Work Order ID 84778

Item Name: Crosstube Fwd

From: David Shepherd <dshepherd@dartaero.com>
Sent: Thursday, August 02, 2012 11:49 AM
To: 'Eric Downing'; 'Alex Pharand'; 'Mike Petsche'
Cc: psmith@dartaero.com; 'L Lacelle'
Subject: RE: D407-667-105 over bent

DART AEROSPACE LTD	Work Order:	84778
Description: Crosstube High Fwd (407)	Part Number:	D407-667-105
Inspection Dwg: D407-667-145	Rev: C	Page 1 of 1

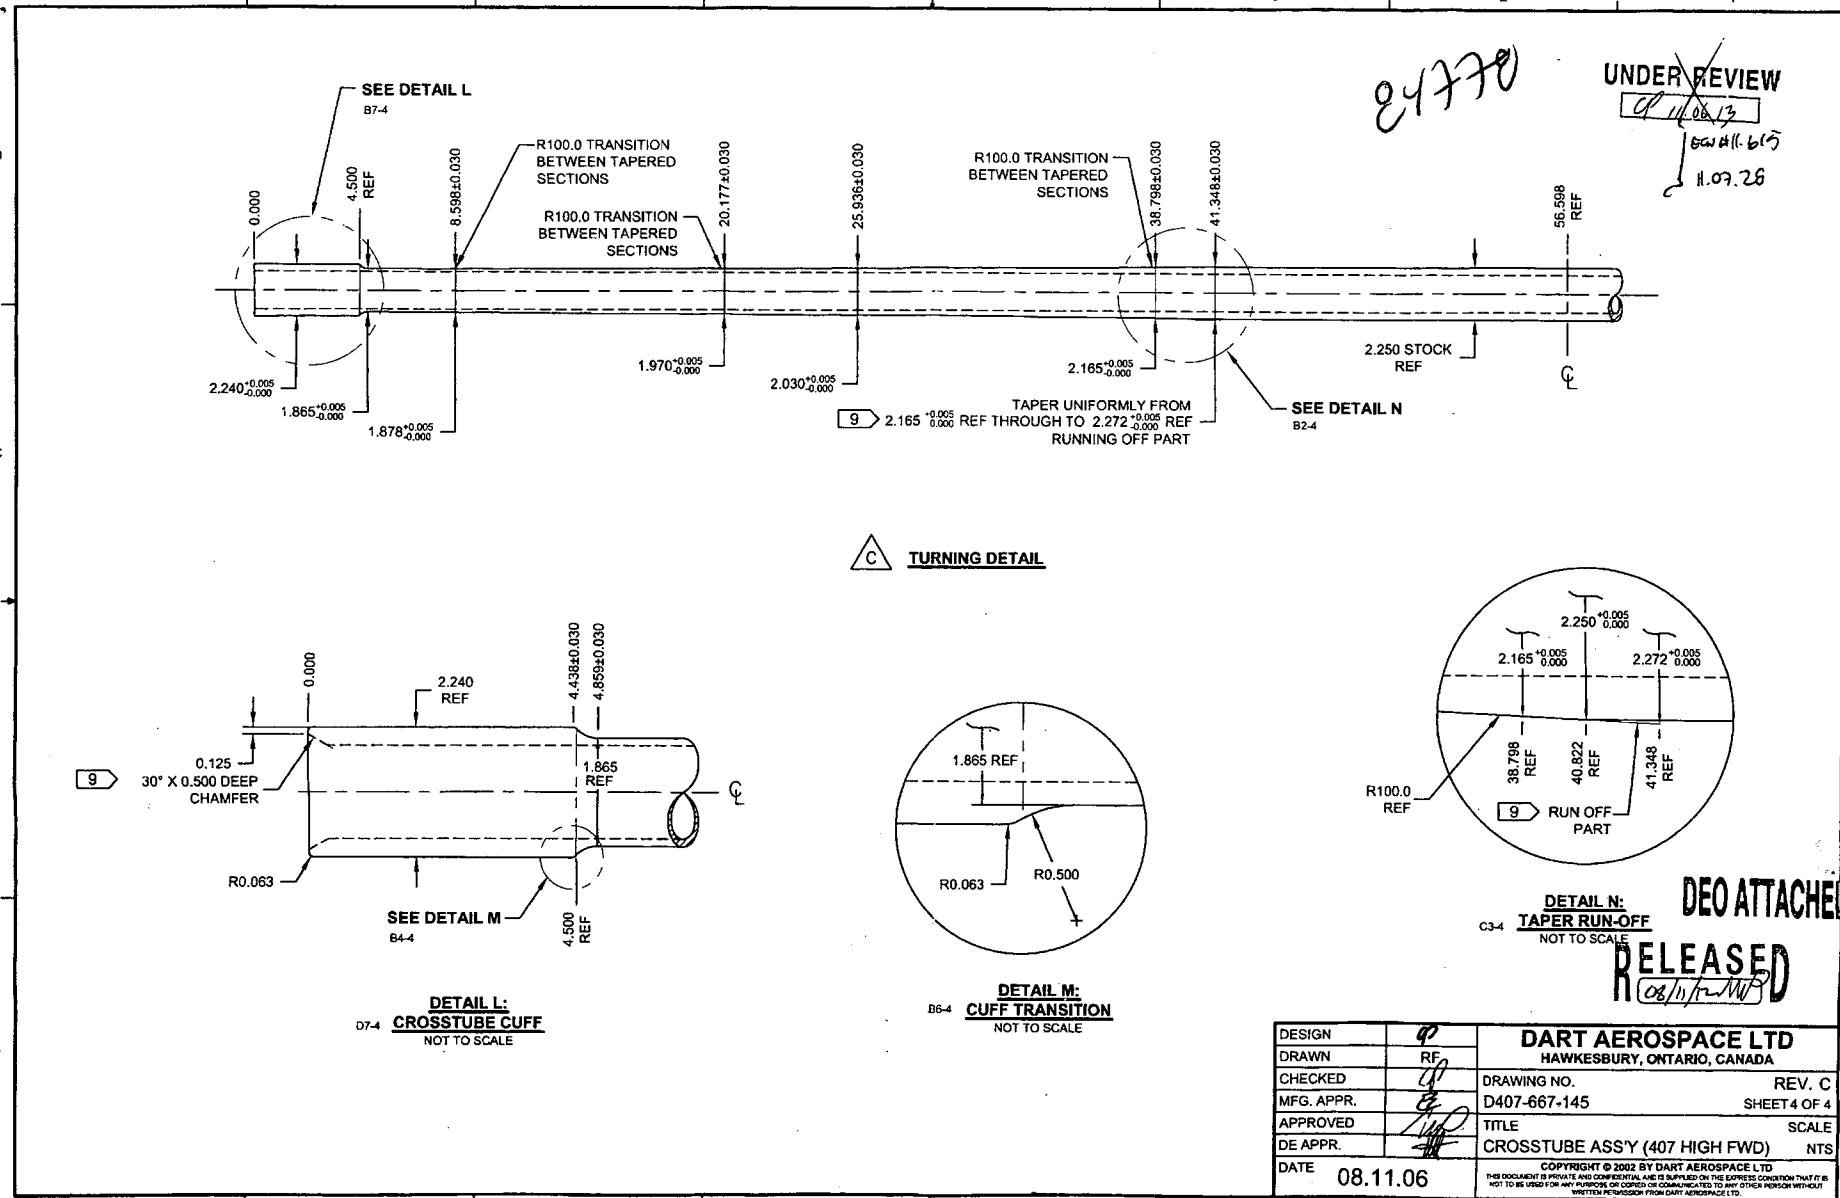
PURPOSE:

REPLACE MAGNOBOND WITH PROSEAL.

IS:

Item	Qty -146	Part Number	Description
9	A/R	PROSEAL 890 B-2	SEALANT, AMS-S-8802 CLASS B-2

WAS:

9	A/R	MAGNOBOND 6398	ROCKWELL SPECIFICATION RBO-120-023 ADHESIVE (TEXTRON/BELL SPEC. 299-947-100, TYPE II, CLASS 2 ADHESIVE)
---	-----	----------------	---

NOTE 12 & 15, SHEET 1 IS AMENDED AS FOLLOWS:

IS:

- 12) TO INSTALL D2891-1 SUPPORT: ABRADE MATING SURFACE OF SUPPORT AND CROSSTUBE WITH 180-GRIT SANDPAPER AND REMOVE RESIDUE WITH MEK (OR EQUIVALENT). APPLY A 0.04" TO 0.07" THICK LAYER OF PROSEAL 890 CLASS B-2 (OR AMS-S-8802 CLASS B-2) SEALANT TO MATING SURFACE OF SUPPORT.
- 15) TORQUE CLAMPS 80 TO 100 IN-LB. ENSURE AT LEAST 1.5 THREADS SHOWING IN SAFETY AND THAT NUT HAS NOT BOTTOMED-OUT AFTER TORQUING. PRIOR TO PACKAGING, RE-CHECK TORQUE ON CLAMPS AFTER PROSEAL 890 SEALANT HAS CURED FOR 72 HOURS.

WAS:

- 12) INSTALL D2891-1 SUPPORT USING 0.03" TO 0.06" THICK LAYER OF MAGNOBOND 6398 PER QSI 015. LET CURE FOR 12 HOURS AFTER INSTALLATION AND PRIOR TO PACKAGING.
- 15) TORQUE CLAMPS 80 TO 100 IN-LB. ENSURE AT LEAST 1.5 THREADS SHOWING IN SAFETY AND THAT NUT HAS NOT BOTTOMED-OUT AFTER TORQUING.
